Proposed Revisions to a Standard Plans Index

Index Number: 120-001

Index Title: Embankment Utilization

Summary of the changes:

LAST REVISION 11/01/18	DESCRIPTION:		FY 2023-24 STANDARD PLANS	EMBANKMENT UTILIZATION	INDEX	SHEET
					120-001	1 of 3

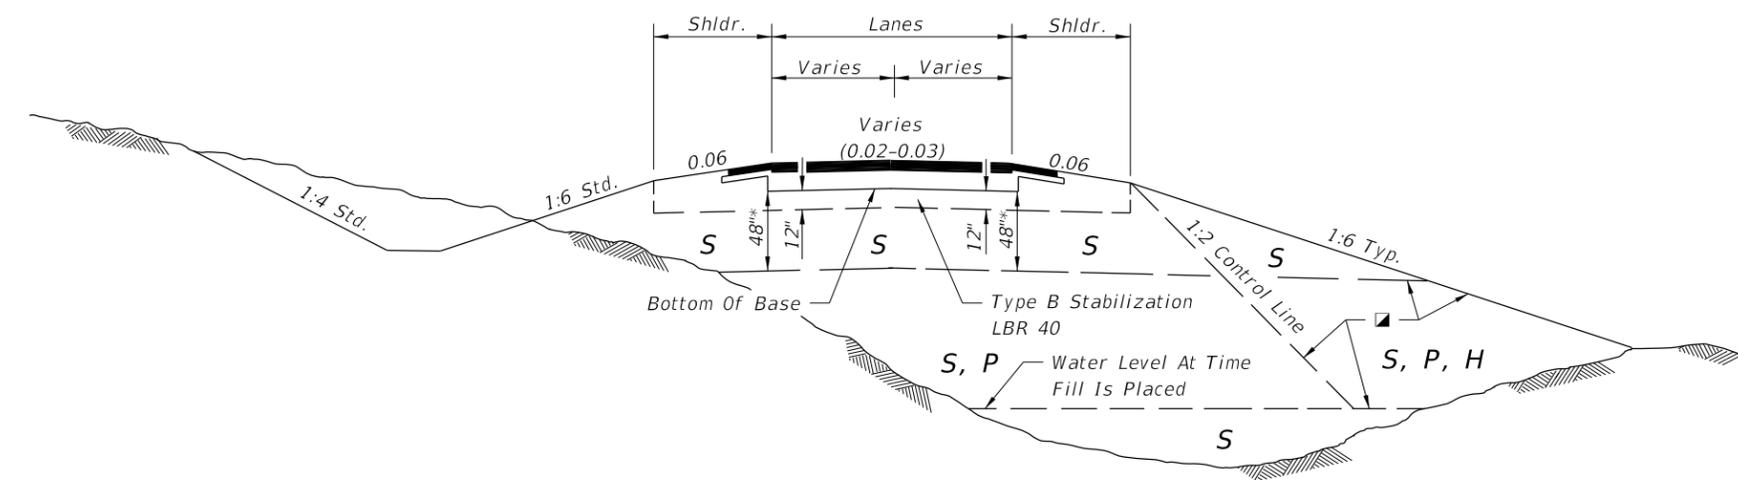
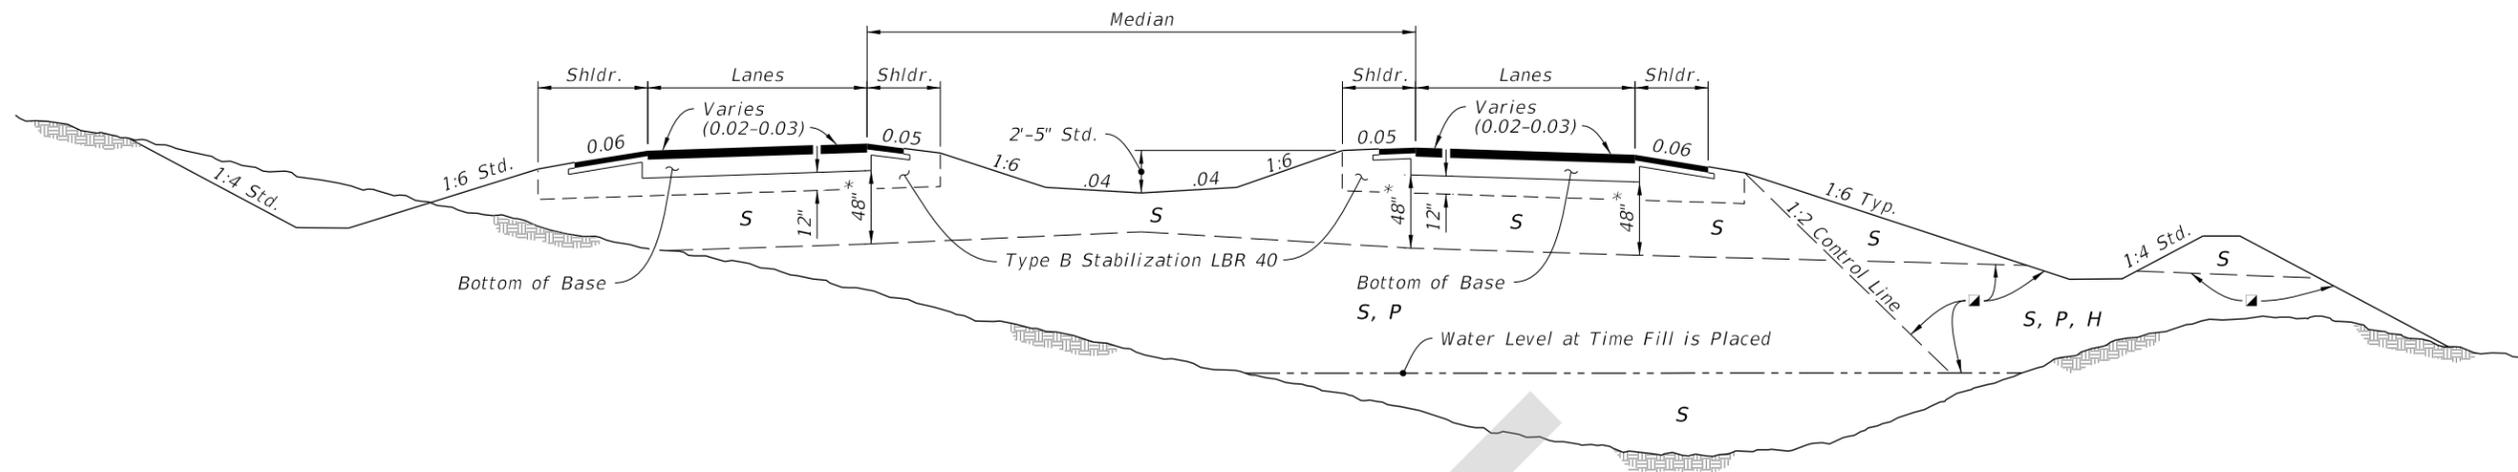
Update Note 4 to reference proper testing

Specification 120 and Index 120-001 have contradicting testing information. Change Index to "Perform tests in accordance with FM 1-T 267."

FM 1-T 267
